# CITY PLAN COMMISSION STAFF REPORT

Parade Park MPD

Docket #2.1 CD-CPC-2024-00097 Docket #2.2 CD-CPC-2024-00096

**CD-CPC-2024-00096** – Rezoning to Master Planned Development

PROPOSED SITE PLAN - PHASE 1

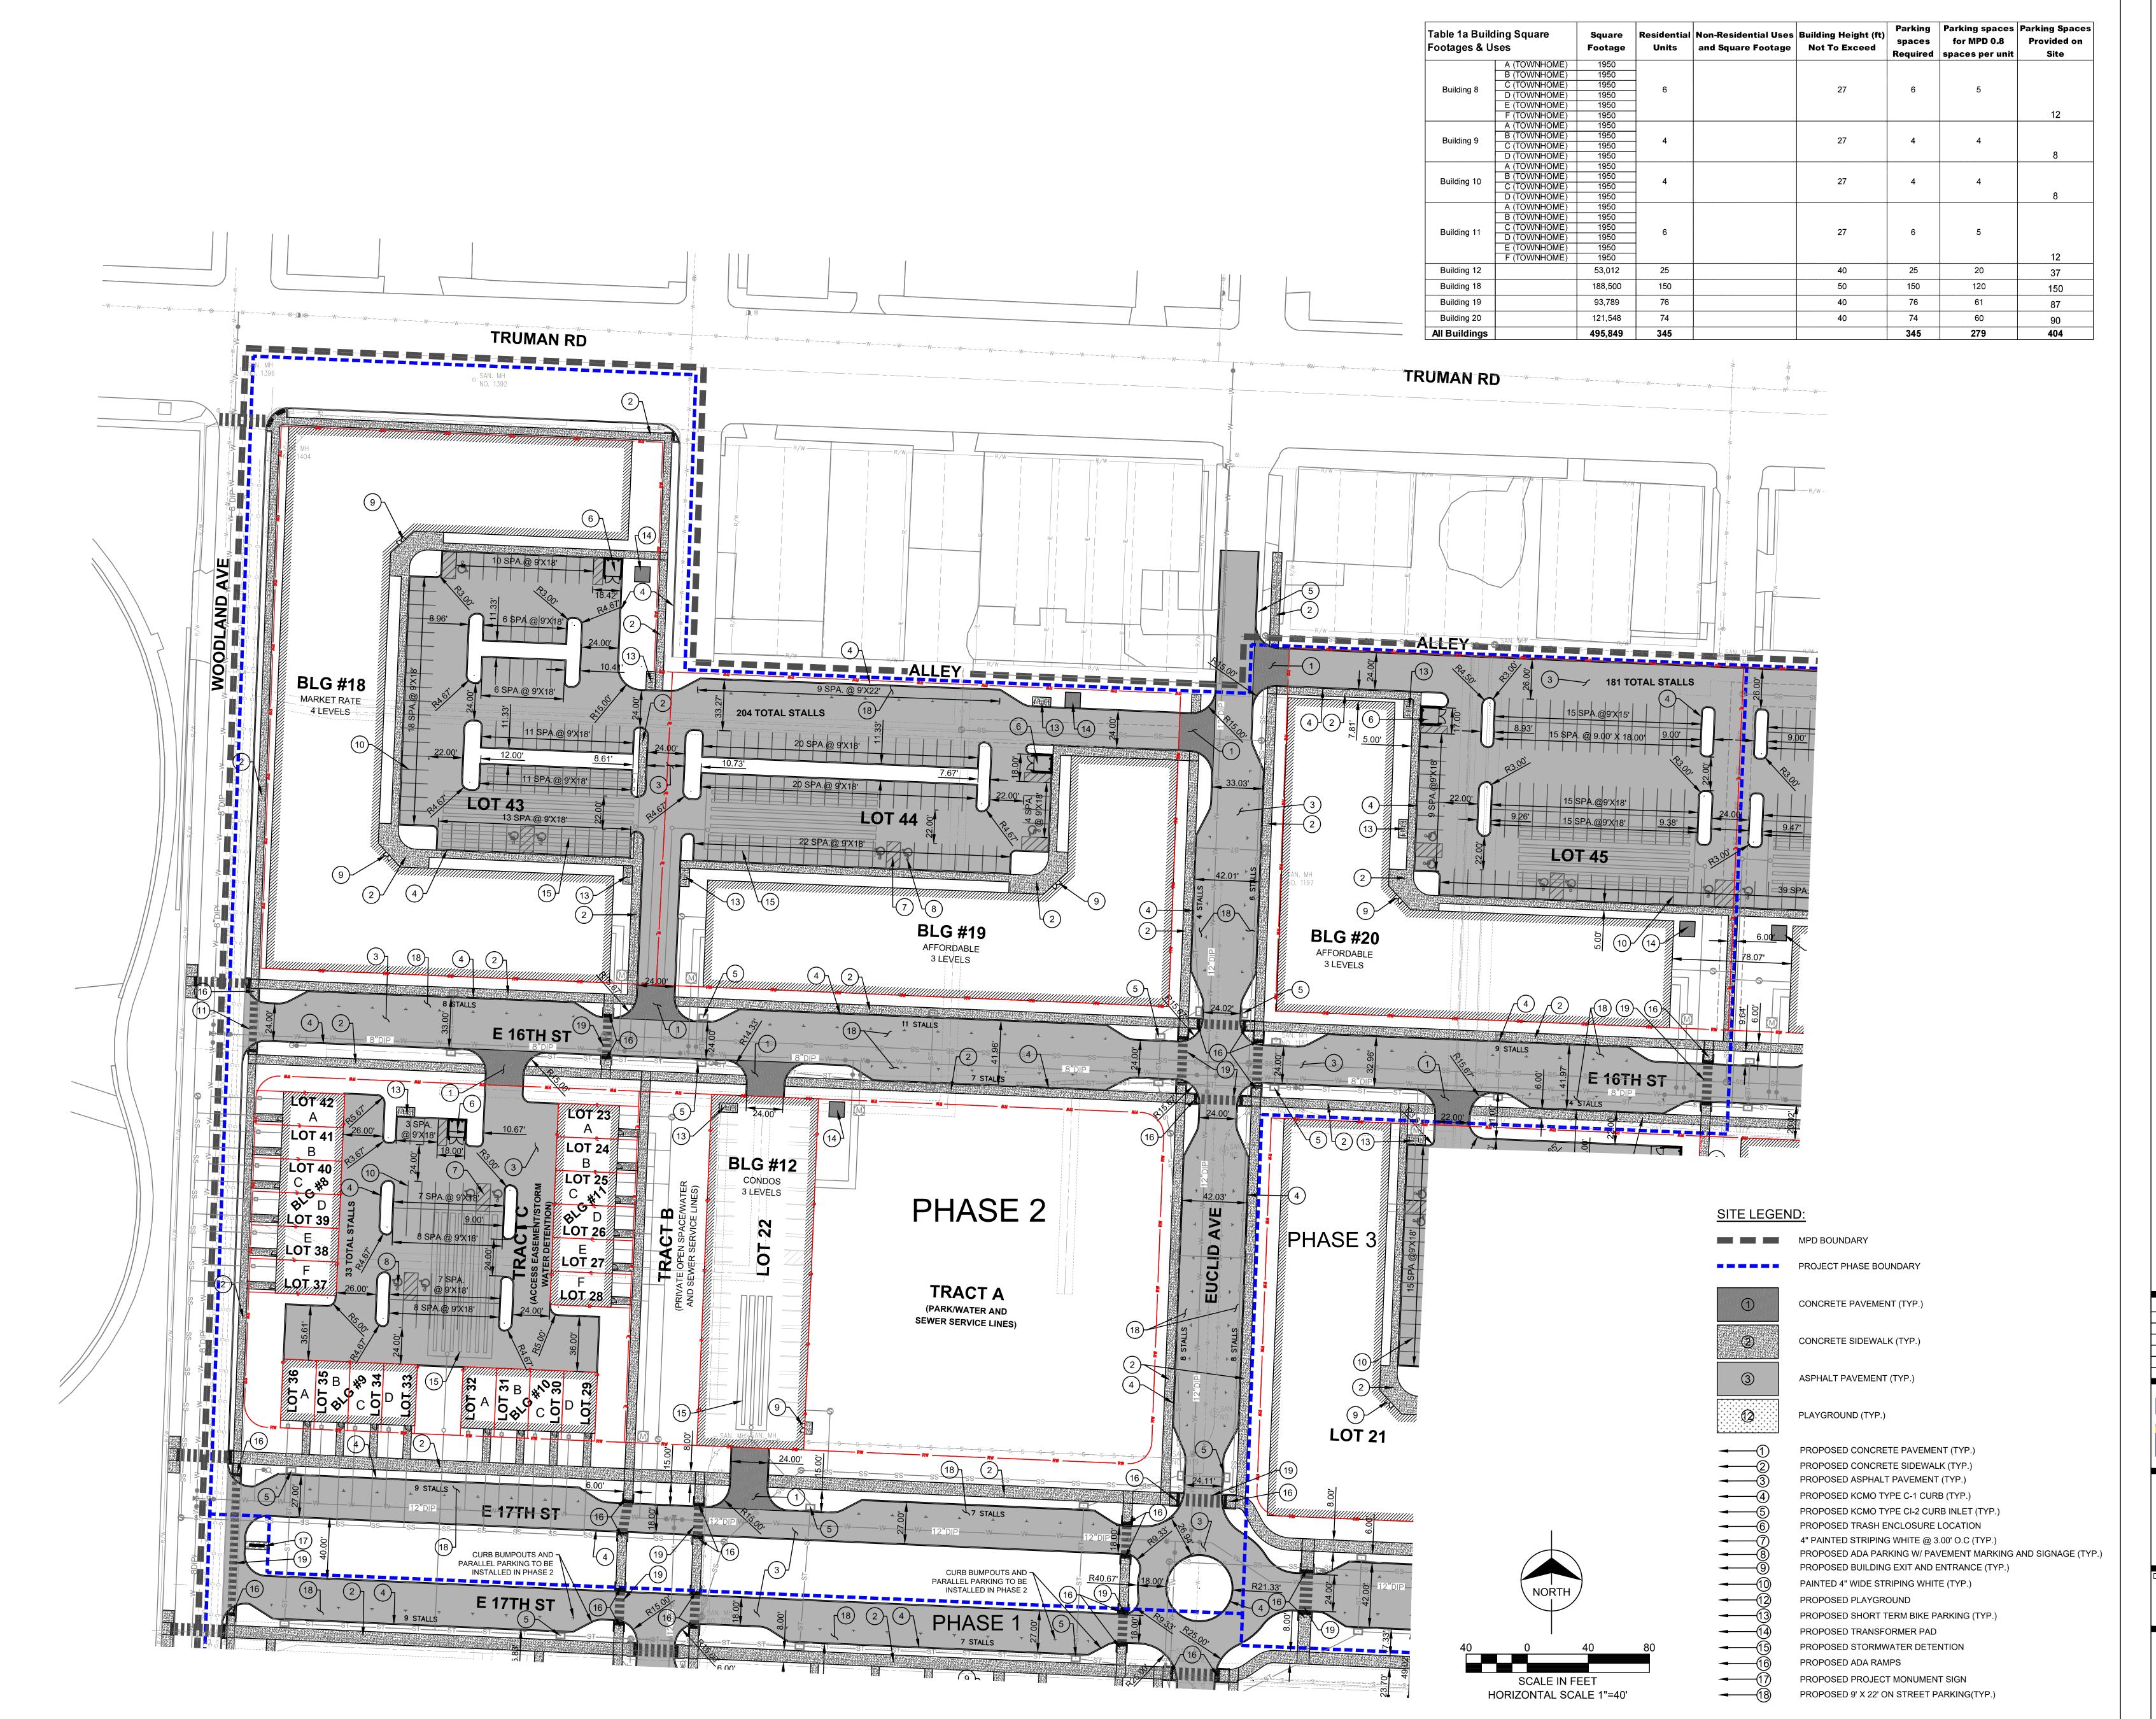
The applicant worked with staff to redesign the location of the "for sale" townhomes in Phase 1 (Buildings 3 & 4). Staff asked the applicant to place the townhomes along Michigan Avenue and provide open space in the location of the townhomes. After discussion with staff the applicant is proposing the townhomes close to Michigan Avenue with the front doors facing each other. Staff is still concerned about the townhomes being surrounded on three sides with parking and tall buildings, however with the front doors facing each other the applicant has created a cottage home like setting.

AFFORDABLE ELEVATIONS

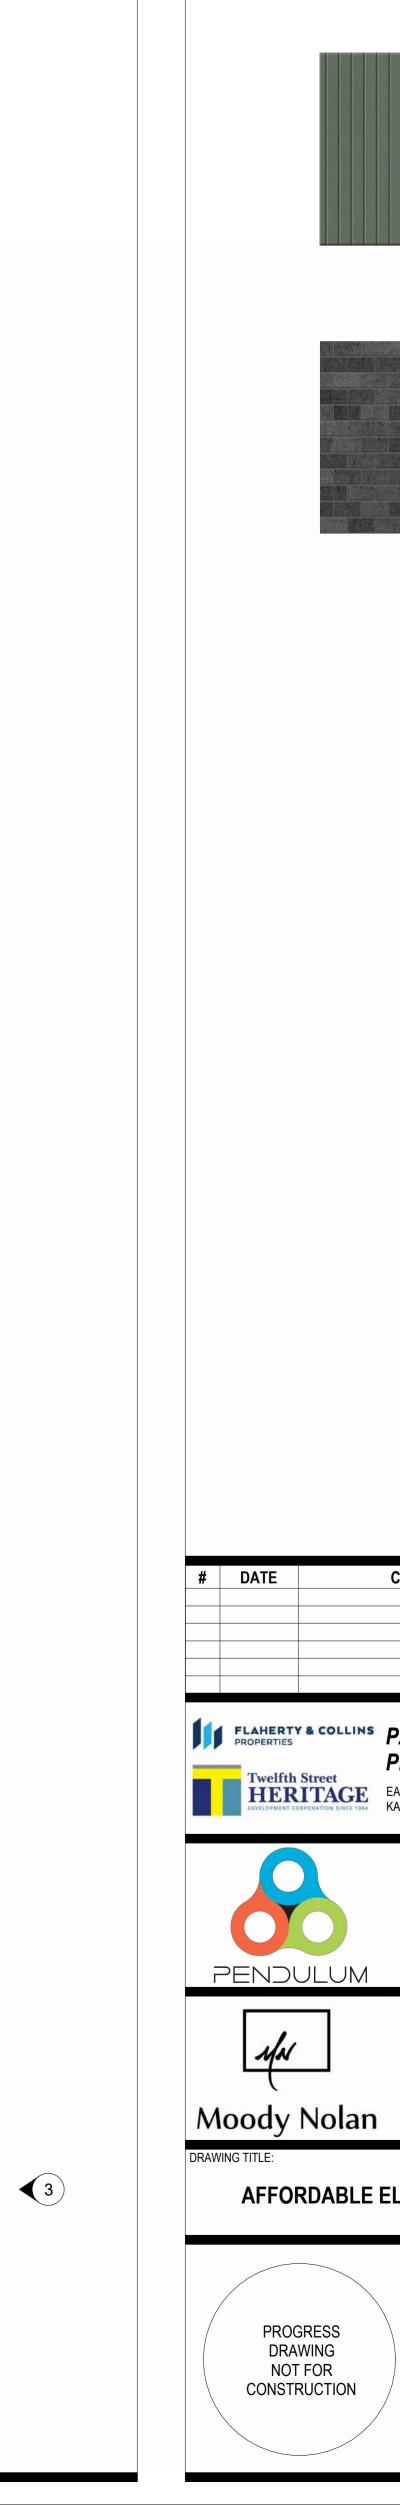
The applicant is required to update the provided elevations for Phase 1 to provide better architectural articulation for the affordable housing building to ensure that the entire development has a cohesive design.

- Shall adjust the labels for the buildings on all plan sheets and architectural drawings.
  - Shall revise the elevations for the affordable building (building 5) to show accurate scale for the grade change, labelled building heights, and the same architectural articulation as shown on the other buildings added.
